Whale Tail 2021 Annual Open Pit Geomechanical Inspection

March 24, 2022

RE: Meadowbank Complex - Amaruq Site - 2021 Annual Open Pit Geomechanical Inspection

Observations - Blasting

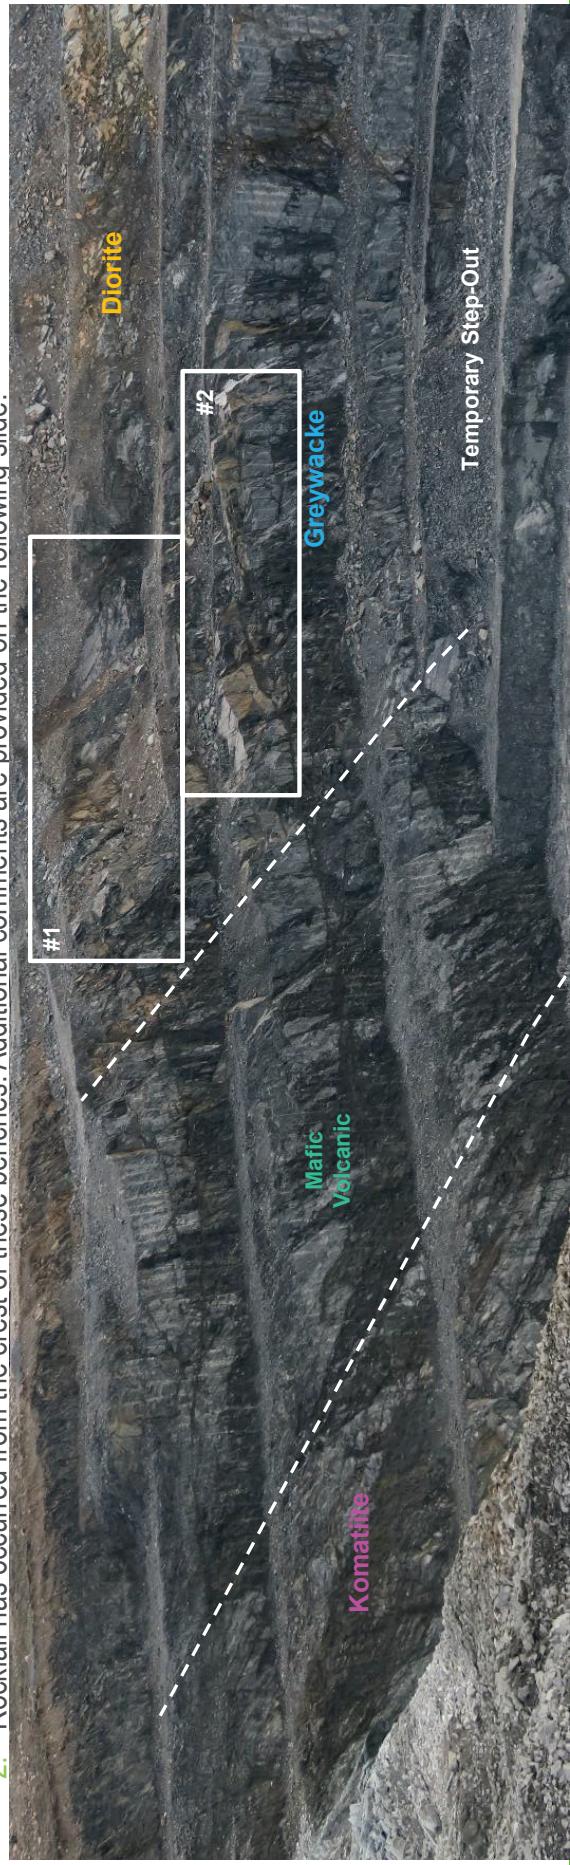
- During the site visit, a relatively large choke blast was taken in the northeast corner of Phase 2. The blast was sequenced so that energy was directed towards the final wall. This will result in increased blast damage to the final walls, particularly when the dominant structure is oriented perpendicular to the wall (as the foliation is in the end wall in this case).
- As part of the on-going blasting study, recommend reviewing the blasting strategy. Where practical, direct blasts away from the final walls.
- From discussions with site staff, there is also a need to implement a drill and blast quality control program and a blast monitoring program.

Observations - East Wall (Cont'd)

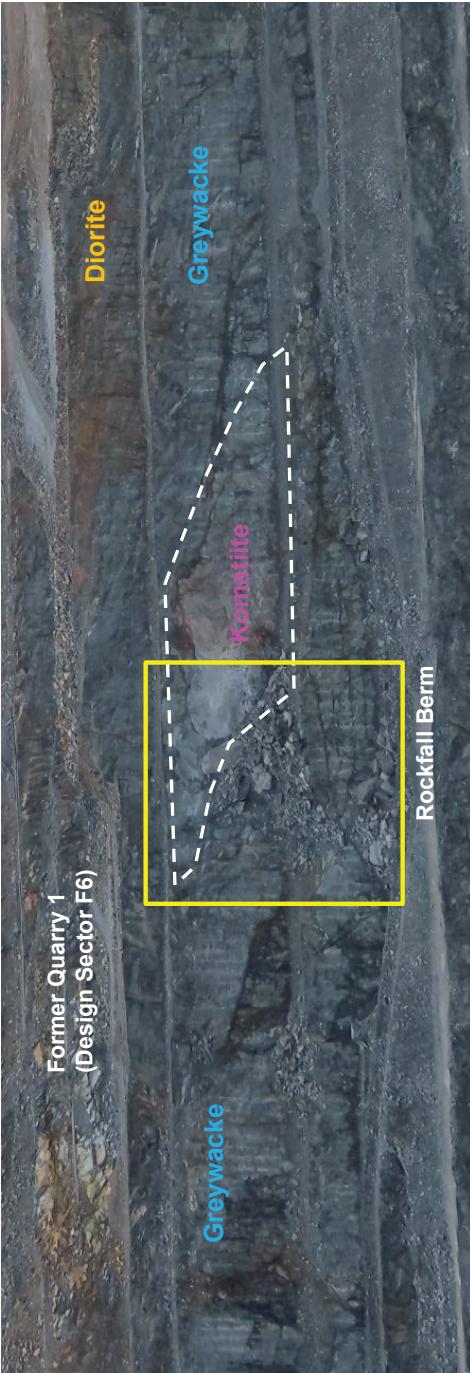
- A rockfall occurred in the southeast corner of this sector in 2021. In response, a rope scaling contractor (Vertika) was brought in to scale the wall (resulting in the loose observed on the catch benches). A series of curvilinear features, potentially associated with Whale Tail lake, are present in this area (outlined in yellow, below right) and likely contributed to the rockfall.

- A temporary step-out has been left below the area to reduce the exposure to personnel. The intention is to scale the area, clean the catch benches and recover the step-out as part of the Phase 3 pushback. This is a reasonable plan. If rockfall hazard persists, could consider additional measures such as mesh.

- Two potentially unstable blocks were observed during the visit (outlined in white, below left). These blocks should be monitored as part of the regular visual inspections. Recommend using the drone to facilitate these inspections given the difficult position of the blocks.

Observations - Phase 2 South Wall

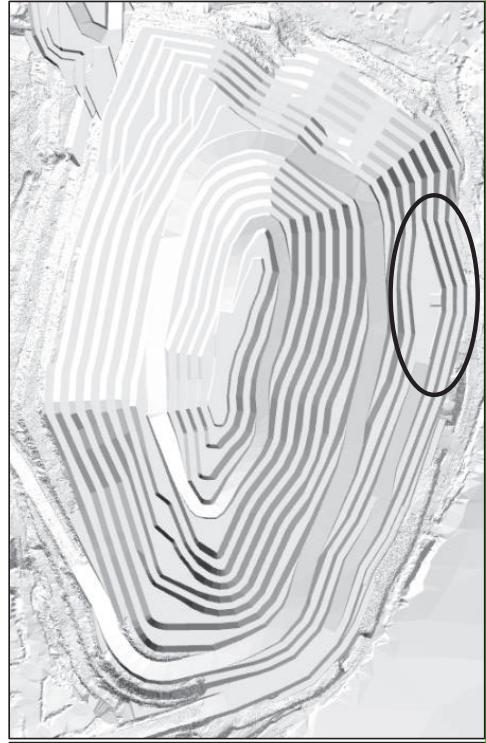
- Interim wall approximately within Design Sector H5. Also referred to as Phase 2 South (H5).
- The wall is generally performing well. Specific areas of note are listed below and outlined on the photo. Details are included on the following slides.
 1. A bench-scale failure occurred along a sub-vertical contact between the Diorite and Greywacke in July, 2021.
 2. Seepage within with the talik associated with Whale Tail occurs in this sector.
 3. A possible unstable block was identified below the ramp.

Observations - Phase 2 South Wall (Cont'd)

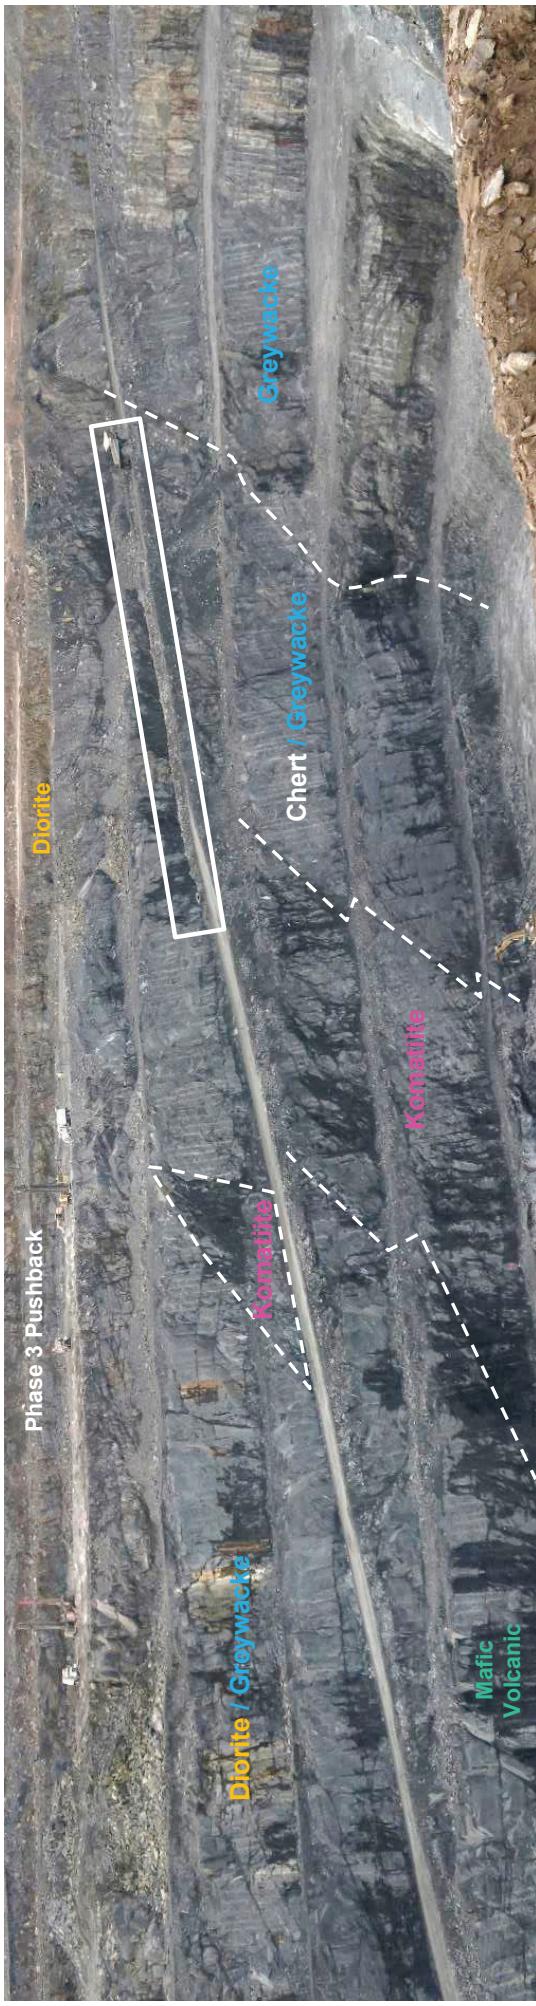
3. A potentially unstable daylighting wedge was identified below the ramp in the South Wall. The wedge appears to be forming on the local Joint Set A (solid yellow line) and a series of cross-cutting structures (dashed yellow line).

- The mine has completed a preliminary stability assessment in Sedge that suggests the wedge has a FoS < 1 (0.9) if the structures are cohesionless and persistent (e.g., no rock bridging). This is likely conservative for a wedge of this size but still indicates that the wedge may not be stable.

- An initial review of the radar data suggests that blasts are causing the wedge to displace (e.g., displacement of 2-3 mm was observed after a blast on September 9). The deformation is focussed on the eastern end of the wedge (circled below), where the wedge is thinnest.

- As the wedge undercuts the ramp, it is recommended that instrumentation be installed to monitor any displacement. As an initial option, a wireline extensometer could be installed. Longer term, a crackmeter or survey prisms should be installed to allow for automated monitoring. In all cases a TARP should be developed for the instrumentation.

- If deformation continues, options for stabilizing the wedge could include constructing a rockfill buttress below it and/or installing dowels to anchor the wedge.

Observations - Northwest Wall (Cont'd)

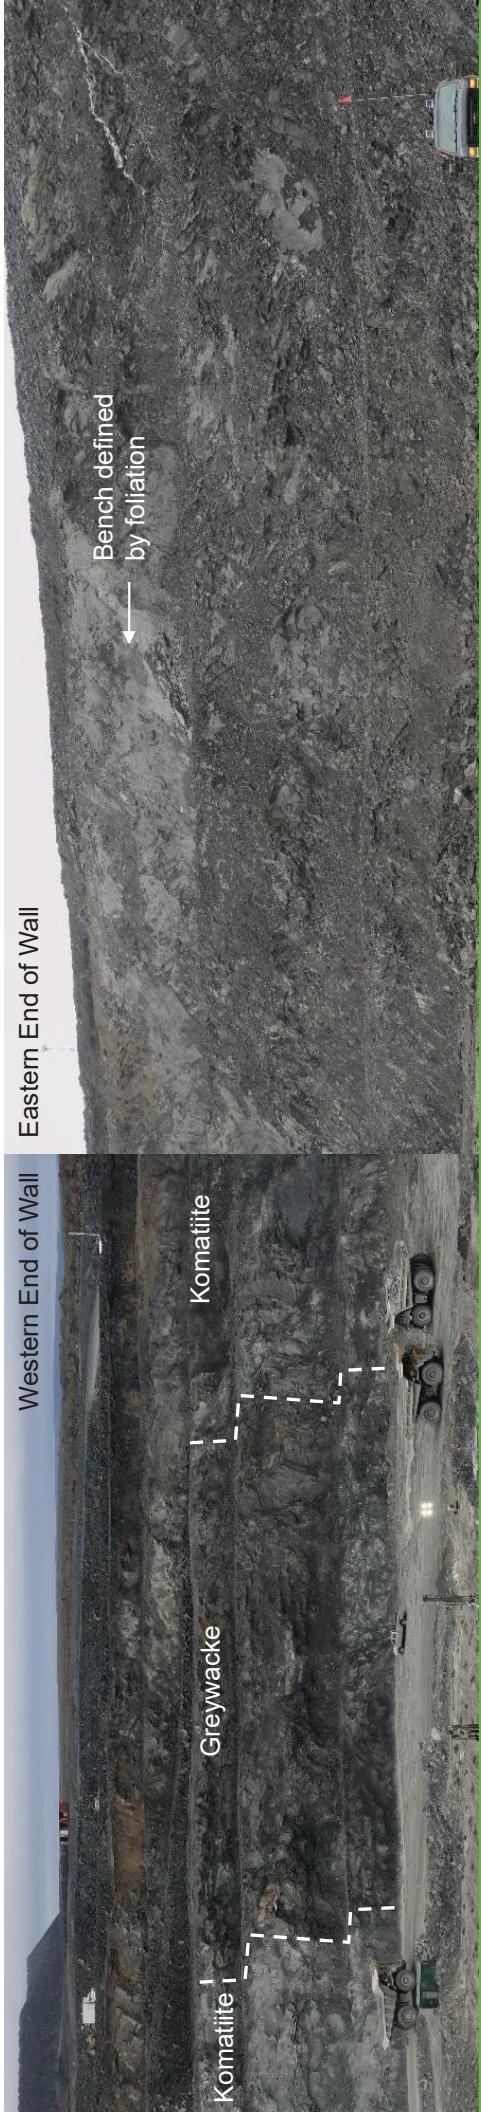
The performance of the Northwest Wall varies significantly along the wall. Observations suggests that this is linked to:

- **Lithology:** Bench faces steeper than the dip of the foliation have been achieved in an interval of Greywacke at the western end of the wall. The Greywacke is more competent than the Komatiite and is associated with increased discontinuity shear strength.

- **Foliation Orientation:** The foliation was expected to be parallel to the wall. Where this has occurred (e.g., the upper benches at the eastern end of the wall), the foliation has typically defined the bench face. However, the strike of the foliation was observed to vary by at least 60° along the wall. Where the foliation is not parallel to the wall, the staggered blastholes induce significant damage to the rock mass, resulting in back break and an irregular bench geometry.

- **Drilling and Blasting:** Discussions with the Drill & Blast Engineer suggested that the depth of the blast holes is poorly controlled and over-drilling is a common problem. Poor depth control will strongly influence the effectiveness of the staggered blastholes used to establish these benches.

Observations - Northeast Wall

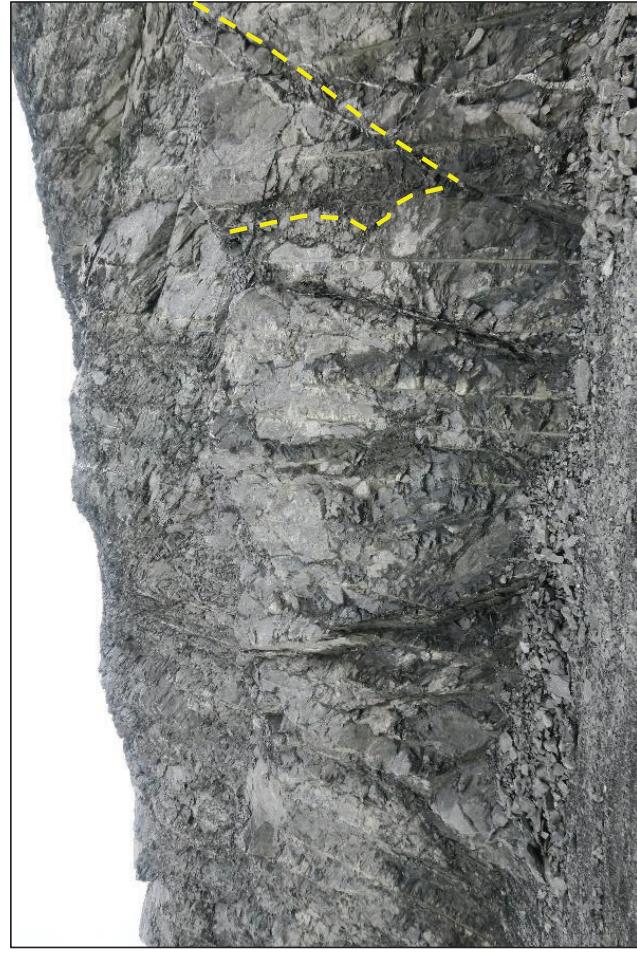
- Final wall in Design Sector V0B.
- In general, the wall is performing well. The foliation is oriented perpendicular to the wall.
- However, cross-cutting structures have resulted in numerous small wedges and it is understood that significant scaling was required when the benches were established. It is expected that the benches will ravel over time. At the time of the inspection, very little material was observed on the catch benches.
- Several potential wedges were observed and are described on the following slide.

Observations

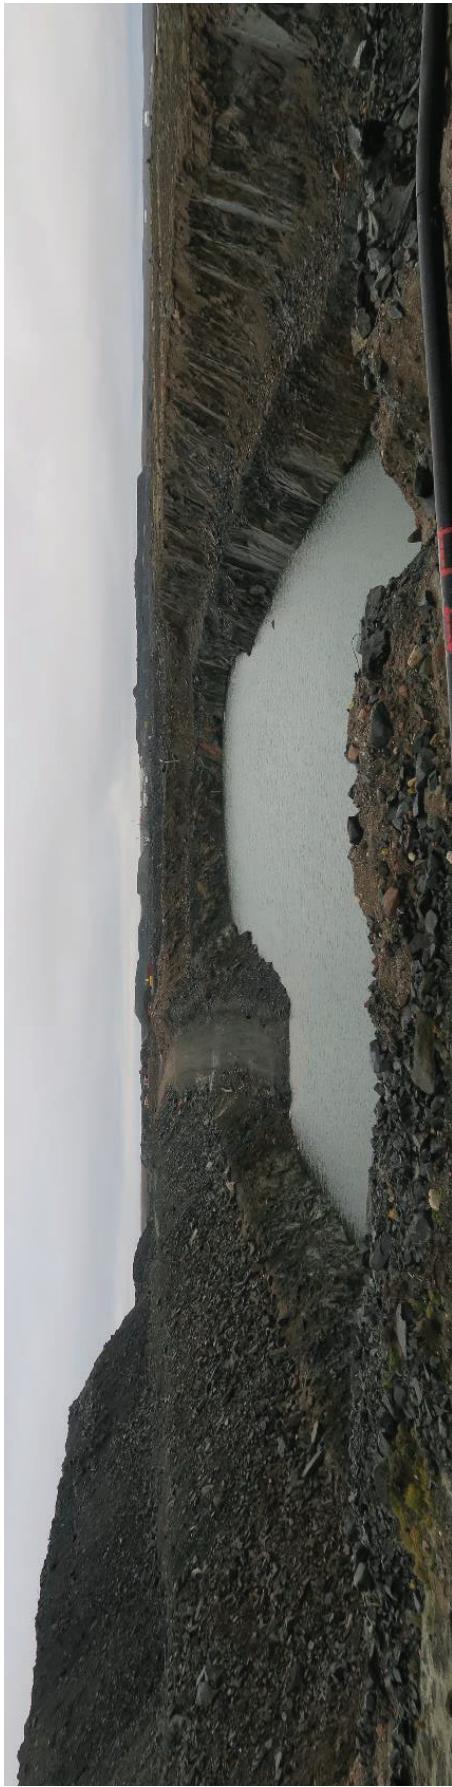
- Attenuation Pond 5 is located to the east of the WHL open pit and was inspected on September 17, 2021.
- The pond is partially flooded, with one to two benches exposed above the pond water level. As a result, a detailed inspection could not be completed.
- No stability concerns were identified in the exposed slopes.
- The pumps and pipelines have been removed from the pond.
- The pond is not currently being used and access to the ramp and the pond is not restricted. It is understood that water management infrastructure will be installed in the future. Recommend placing pylons at the top of the ramp to restrict access while it is not being used.

Bench Approval Process

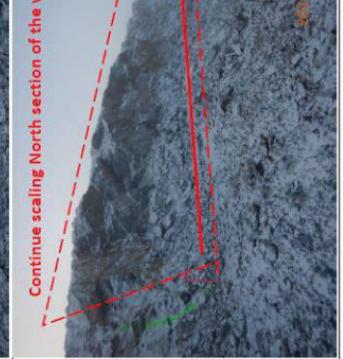
- The rock mechanics group has implemented an approval process for the benches on the final walls (both ultimate pit and interim stages).
- The condition of the bench and whether or not the face has been adequately scaled is assessed. The process is intended to be completed after each 7 m bench is established and before work resumes in the area. A standard two-page report is issued each time.

- This process is a key control for managing potential rockfalls and bench-scale instabilities. While it appears to be well established, it is largely informal; a procedure has not been developed and a formal commitment to the process has not been made. Recommend formalizing the commitment to complete the process for all final walls.

- Recommend developing a simple tracking method (e.g. coloured lines on a plan) for the approvals to reduce the likelihood of this occurring.

SSR Monitoring - Comments

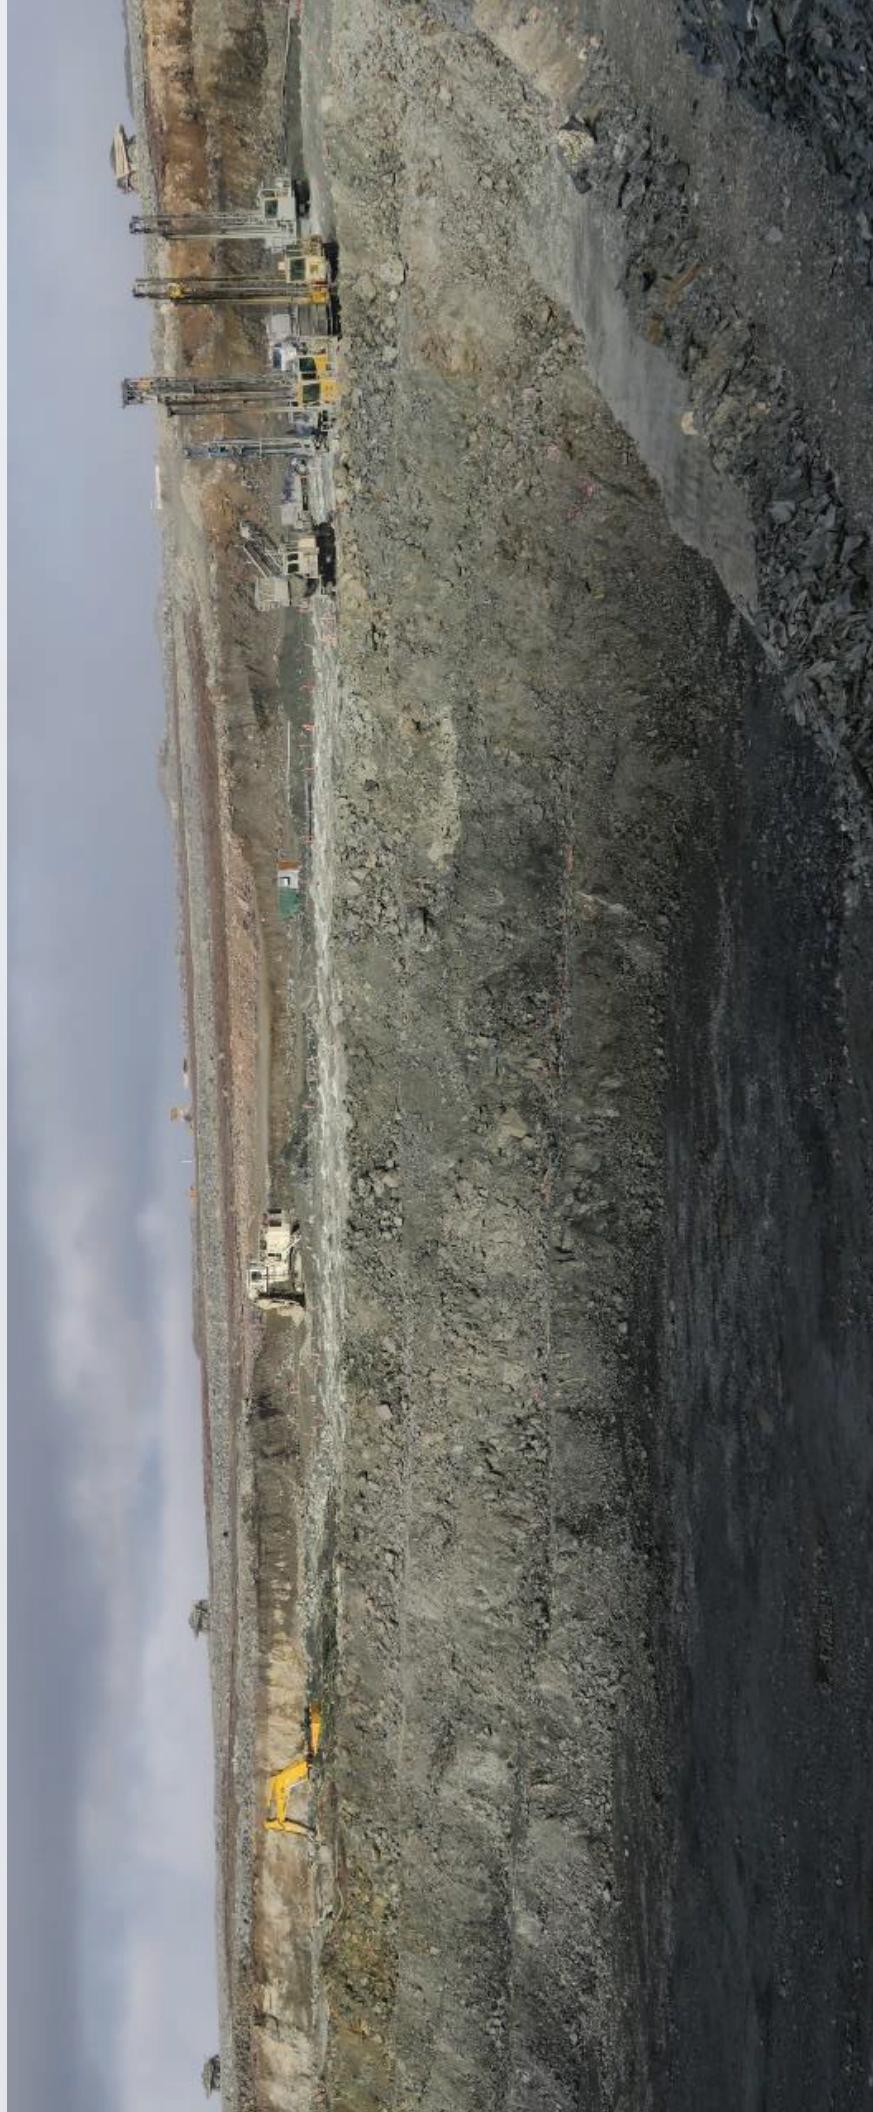
- SSR is best suited to larger-scale failures and is less effective at identifying the brittle bench-scale failures that have been the primary type of instability to date in the Whale Tail Pit. Care must be taken to avoid over-reliance on the radar and a resulting sense of complacency. The Rock Mechanics group is aware of this limitation.

- One possibility for potentially improving the ability of the SSR to predict the bench scale failures is to use one of the radar units tactically and position it closer to the working area to reduce the pixel size and scan times. Alternatively an additional mobile radar unit could be procured. There may also be an opportunity to use thermal monitoring or rockfall radars as a supplement or alternative. A risk-based review of the management of rockfall is recommended to help with the selection of the appropriate tool.
